STRUCTURAL ENGINEERING

Subject: Foundations plan

Date: July 2, 2019

Figure 1: Roads around the building.

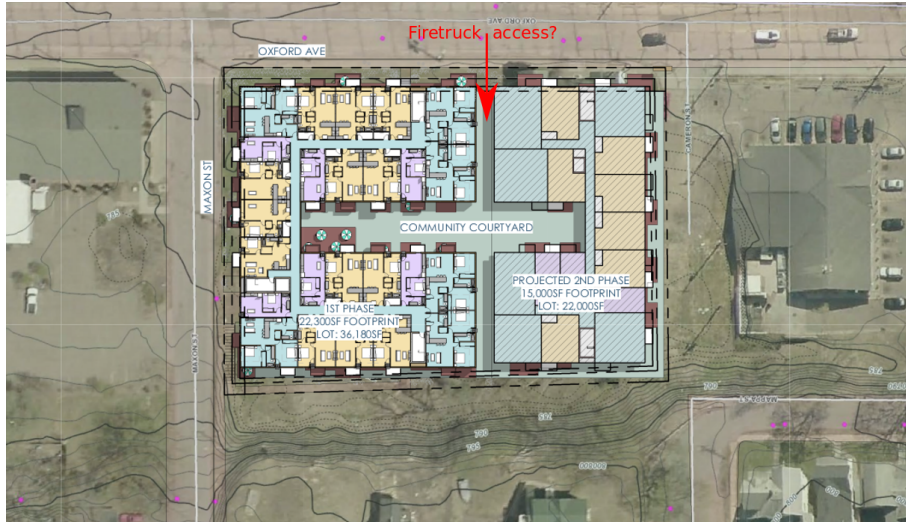
1.3.2 Fire truck access to the courtyard (plaza)

We have not taken into account any fire truck load. @Ryan: it's planned the access of fire trucks to the courtyard? In that case we will need to fix the loads according to sections 1607.7.1 and 1607.7.2 and update the loads plan sent to County materials. We will need to recalculate the footings also.
